PURCHASING

MEMO TO: Prospective Bidders

SUBJECT: **Addendum #4:** Locks Creek Drainage Improvements

CITY OF FAYETTEVILLE -
LOCKS CREEK DRAINAGE IMPROVEMENTS

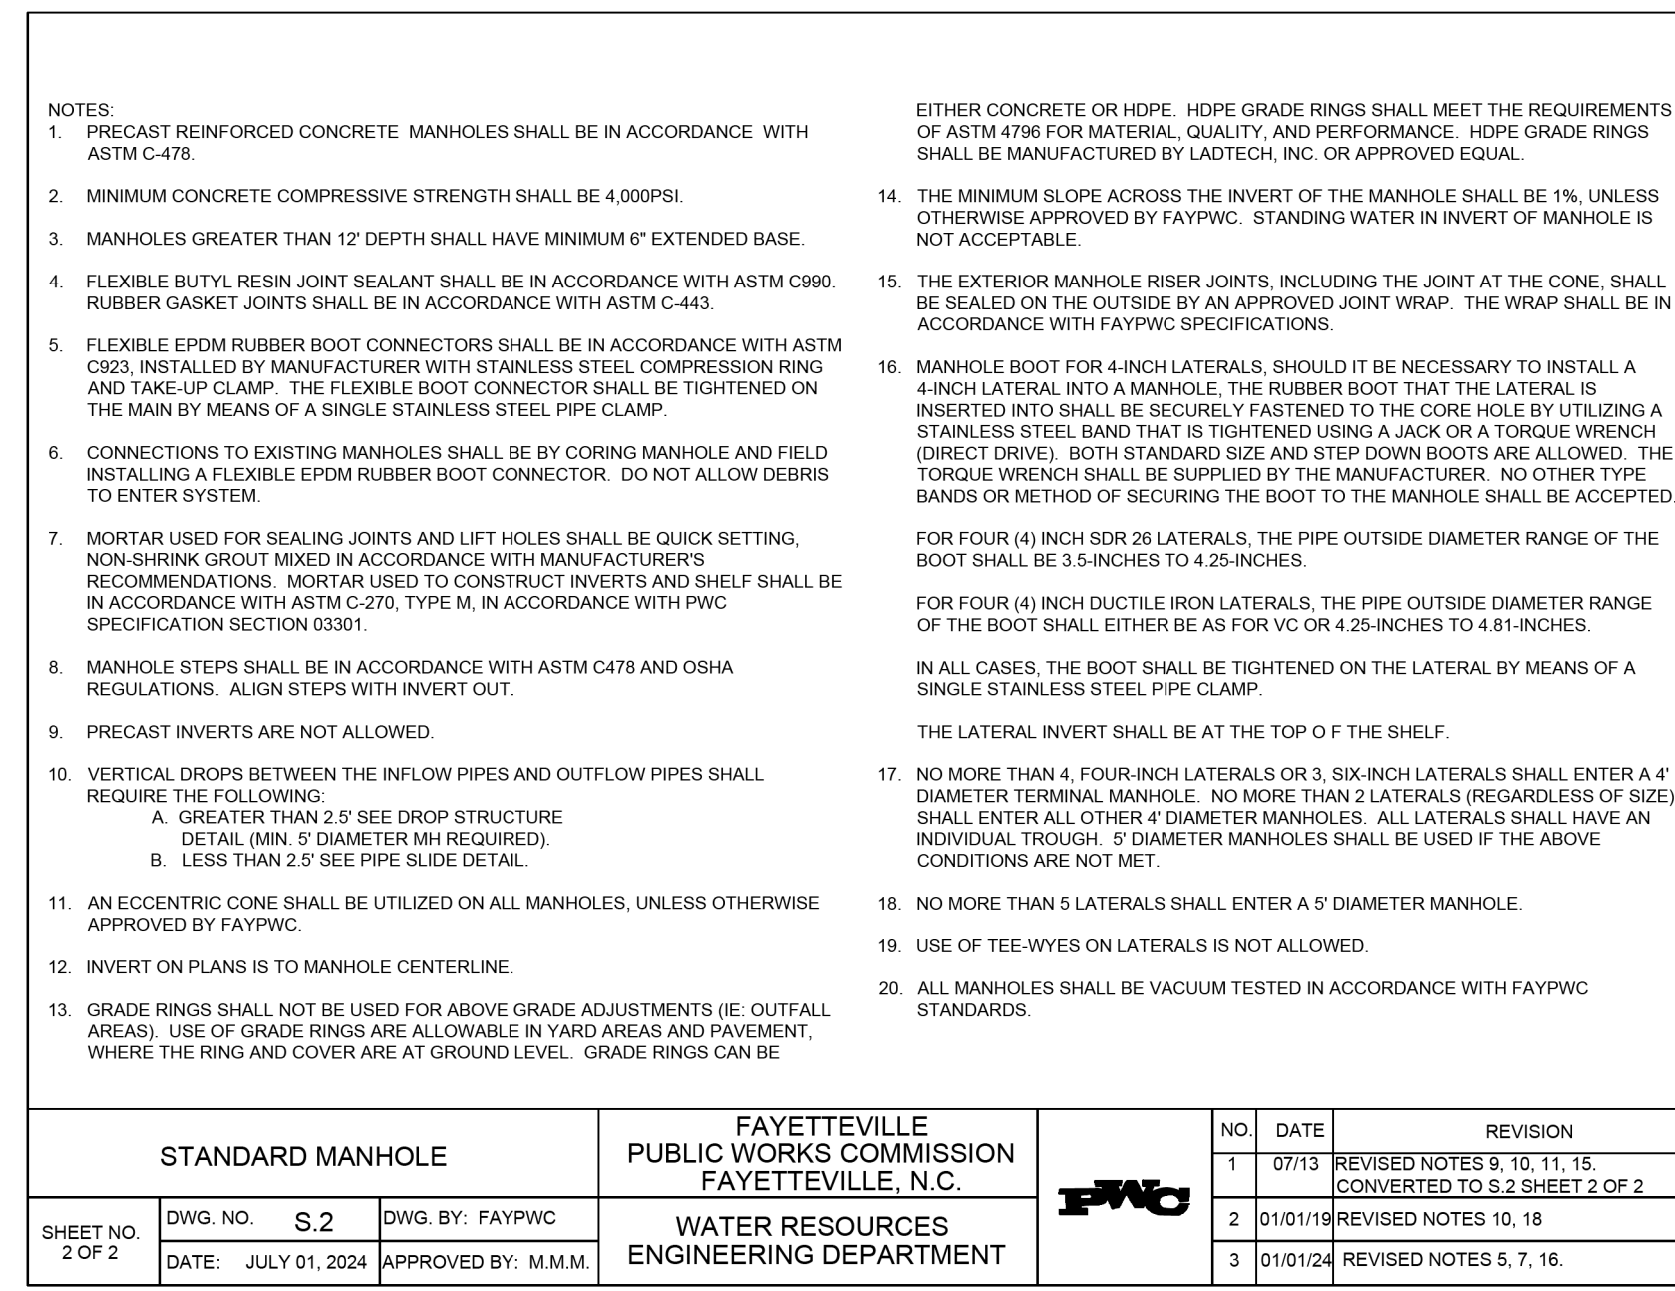
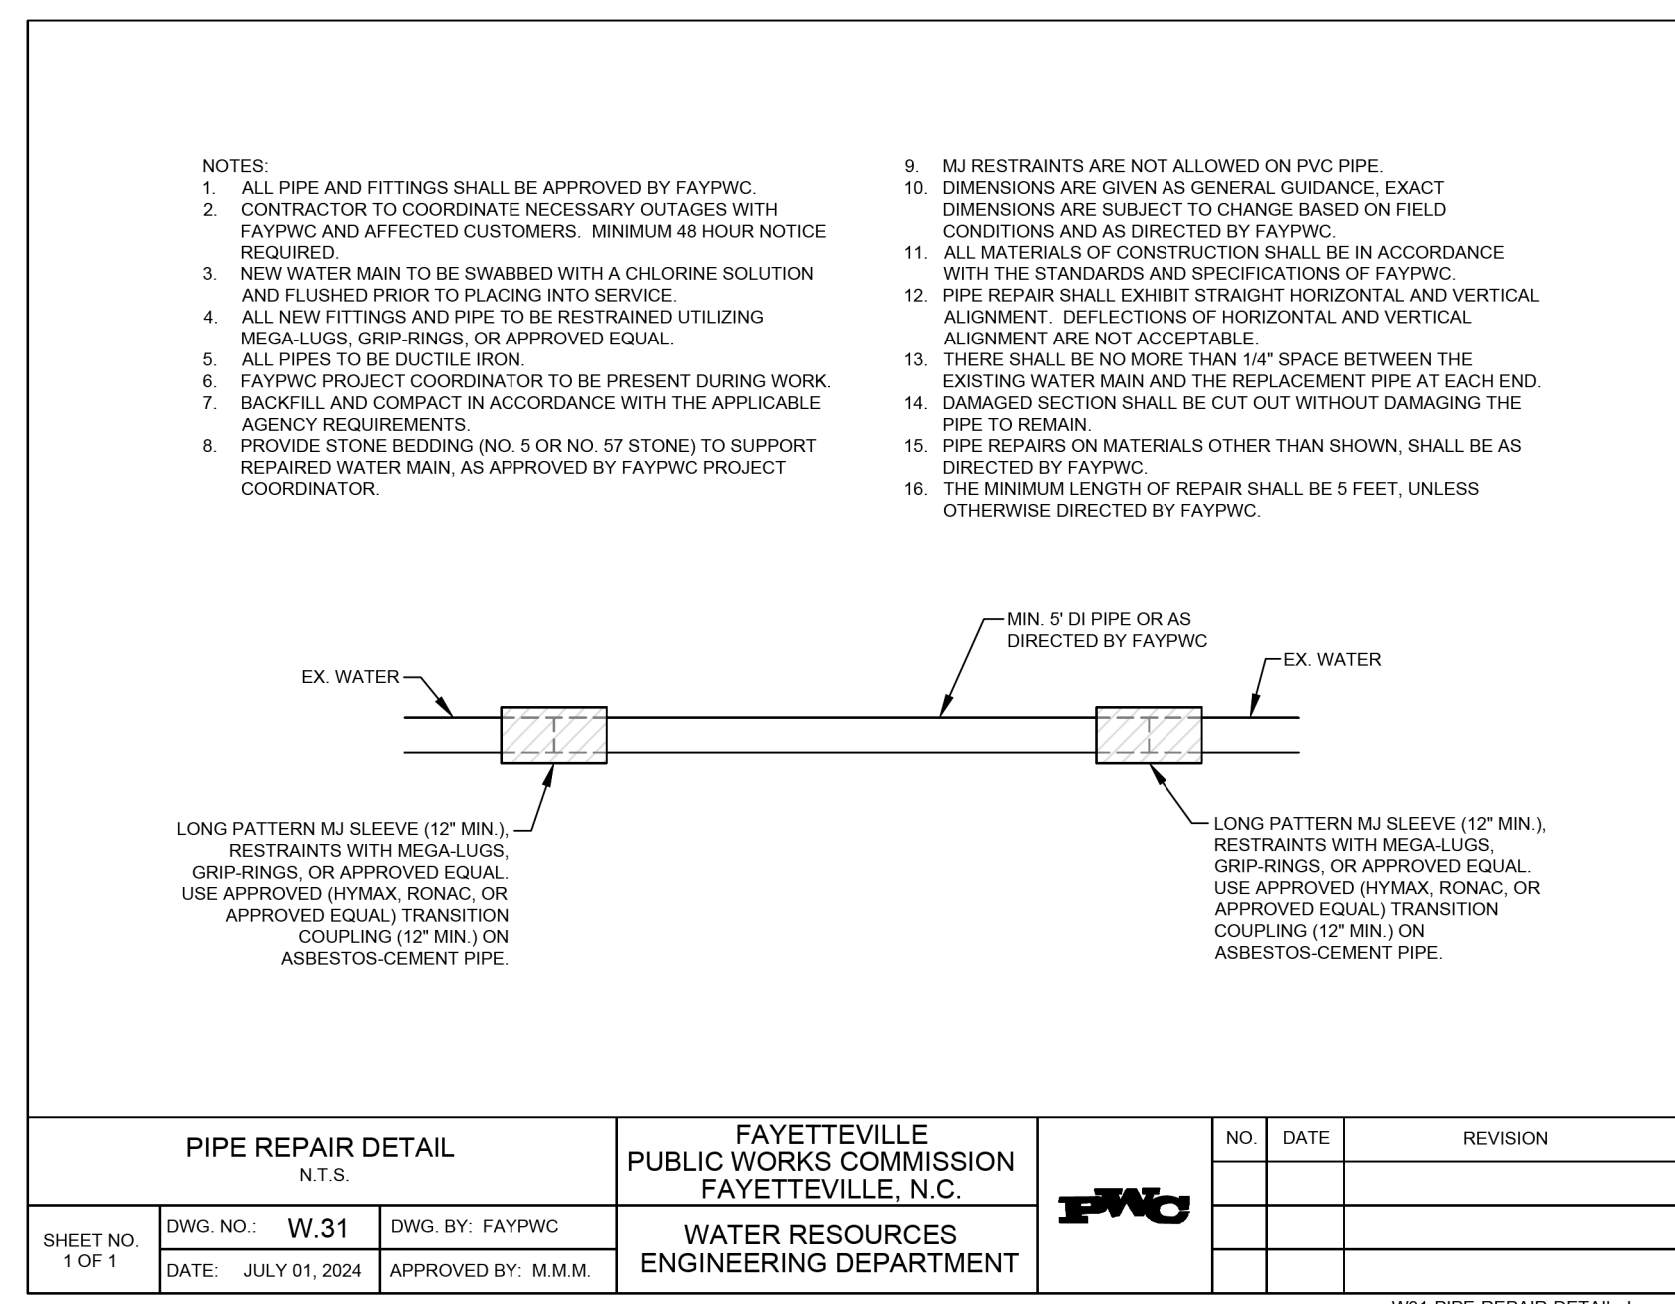
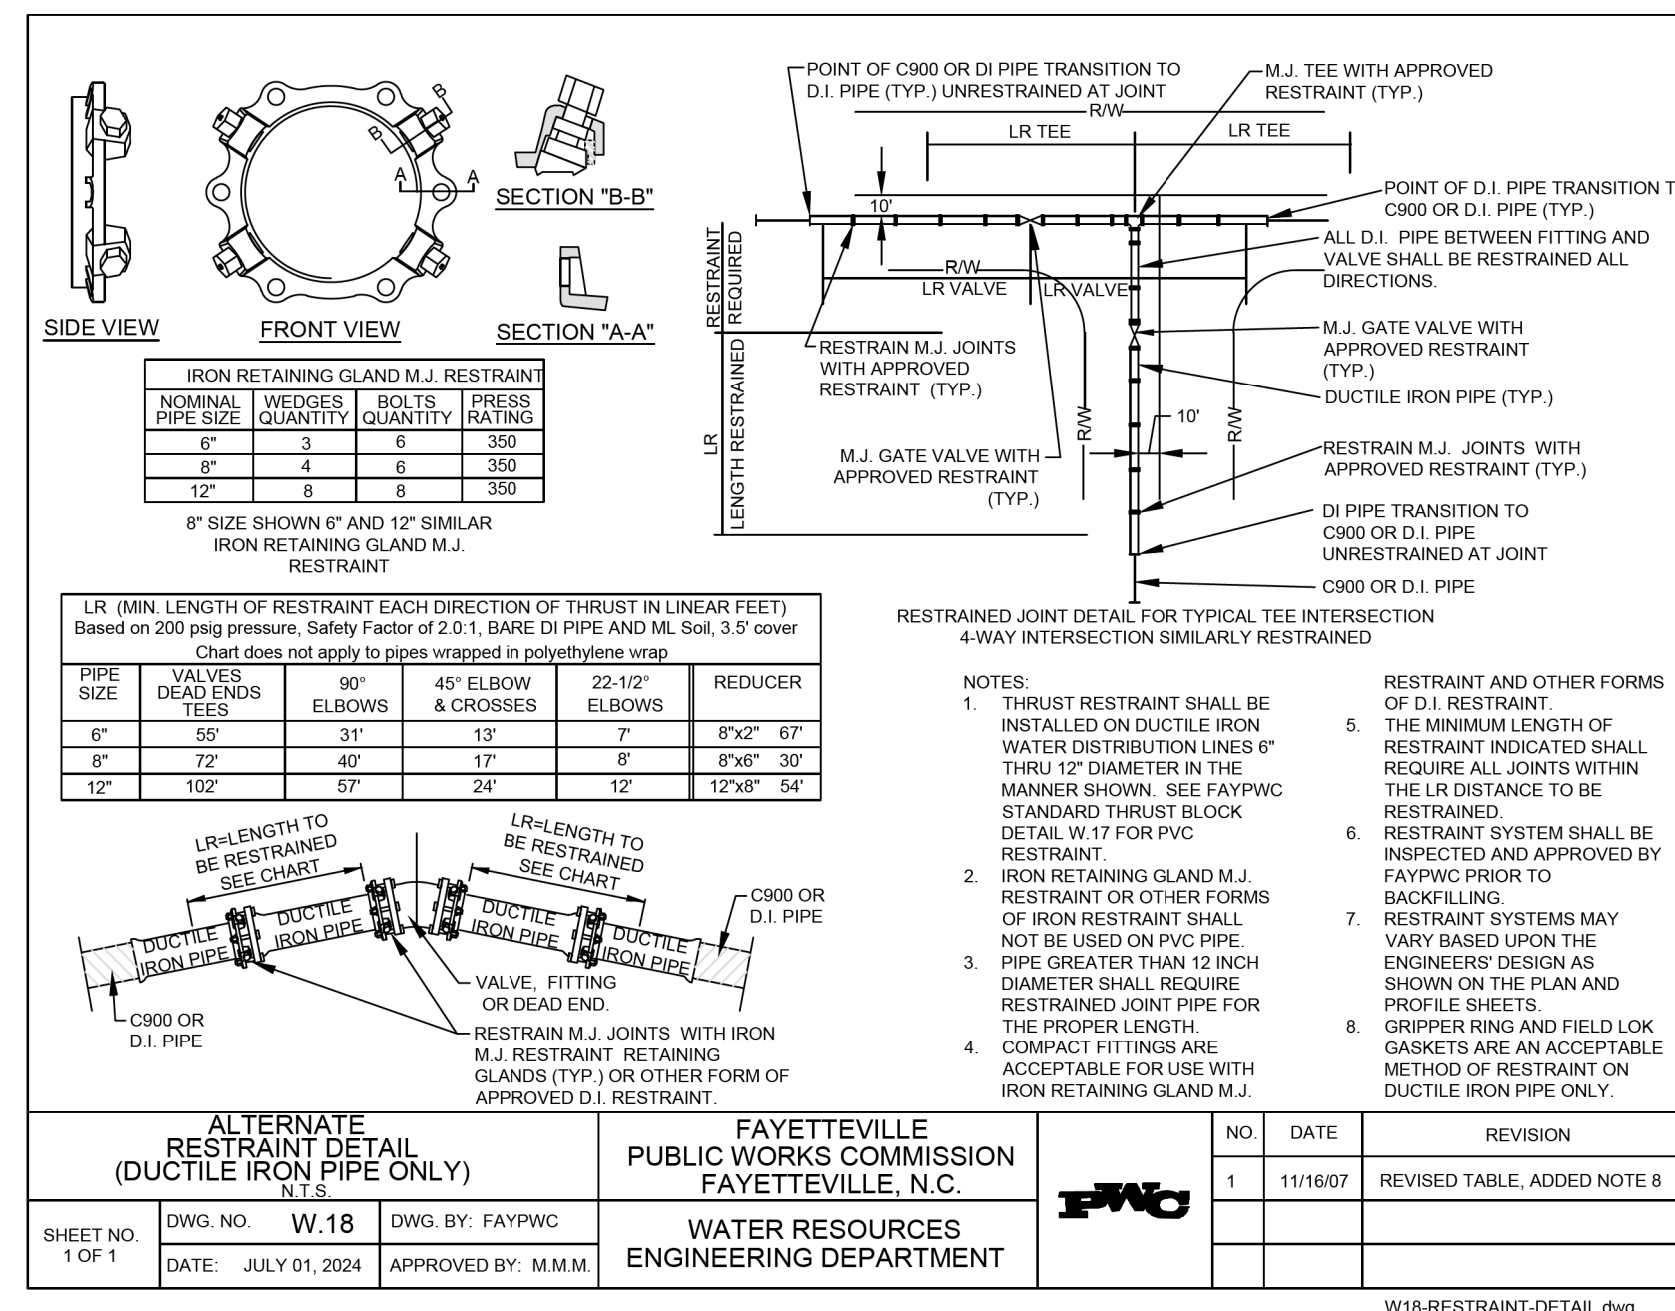
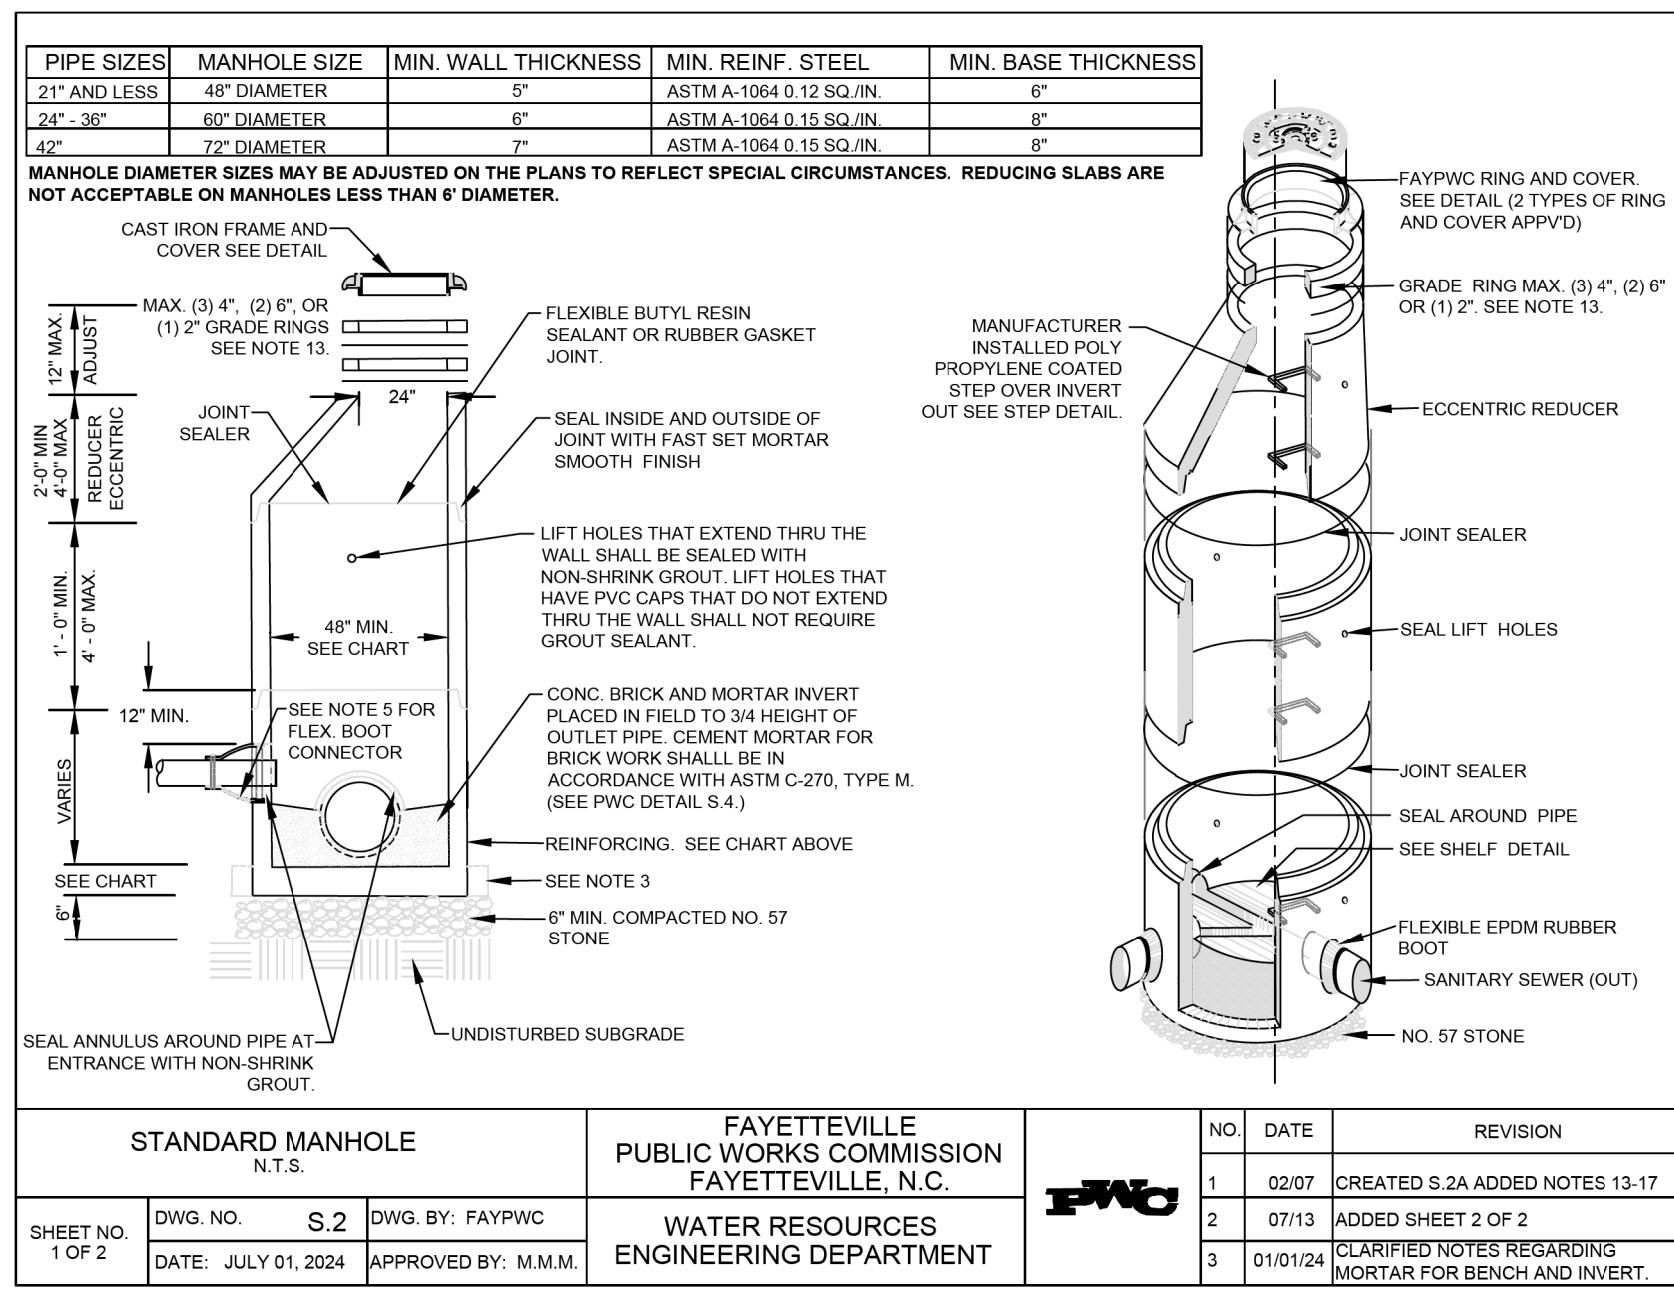
- i. CU-01 with revised water main design
- ii. CU-02 with revised water main design
- iii. CU-02A showing temporary water main bypass
- iv. CU-03 referencing updated construction sequencing on other sheets
- v. DT-04 – construction detail sheet with addition of fire hydrant assembly

- PROVISION OF TEMPORARY WATER MAIN TO ACCOMMODATE BOX CULVERT CONSTRUCTION AND UTILITY WORK RELATED TO REMOVAL AND REPLACEMENT OF FAYETTEVILLE PVC - 8" WATER MAIN:

- TEMPORARY WATER MAIN PLAN LAYOUT:
- TEMPORARY 6" WATER MAIN BYPASS SCHEMATIC LAYOUT ROUTE SHOWN ON THIS PLAN. THE BYPASS SHALL BE INSTALLED TO ACCOMMODATE FAYETTEVILLE PWC REQUIREMENTS TO MINIMIZE SERVICE DISRUPTION FOR THE REMOVAL AND RELOCATION OF THE EXISTING 8" WATER MAIN. THE CONTRACTOR SHALL PROVIDE A DETAILED PLAN, SHOP DRAWINGS AND SUBMITTALS TO THE ENGINEER AND FAYETTEVILLE PWC FOR REVIEW AND APPROVAL PRIOR TO IMPLEMENTATION AND COMMENCEMENT OF THE WORK AND IN ACCORDANCE WITH THE STANDARDS AND REQUIREMENTS NOTED ABOVE.
